May 18, 1983

Re: Catawba Nuclear Station
Docket Nos. 50-413 and 50-414

Duke Power Company
Catawba Nuclear Station
Unit 1 Steam Generator Modification

FEEDWATER SYSTEM CHANGES
CATAWBA NUCLEAR STATION
Figure 1

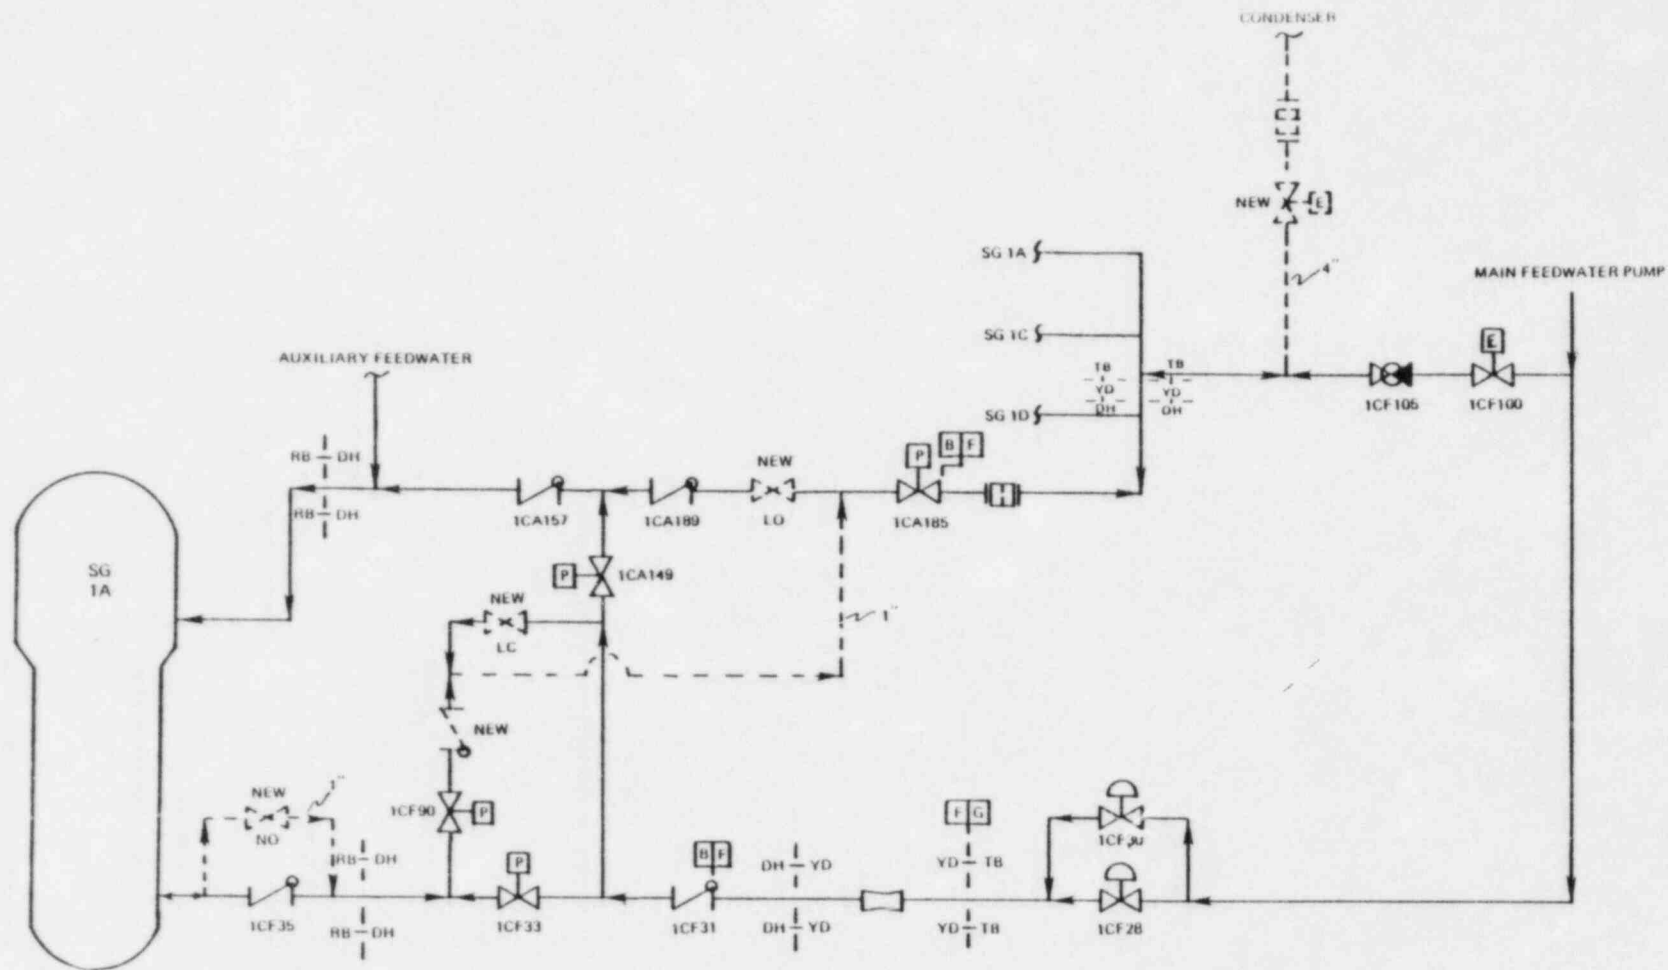
Feedwater system piping changes will be made at Catawba to add additional margin for the forward flushing transient. Instead of using forward purge flow to warm the feedline, hot water from the steam generator will be used. This reverse flushing of the feedline eliminates the thermal transient on the manifold which adds additional margin to the stressed bolts. The piping changes are shown on Figure 1 with dashed lines.
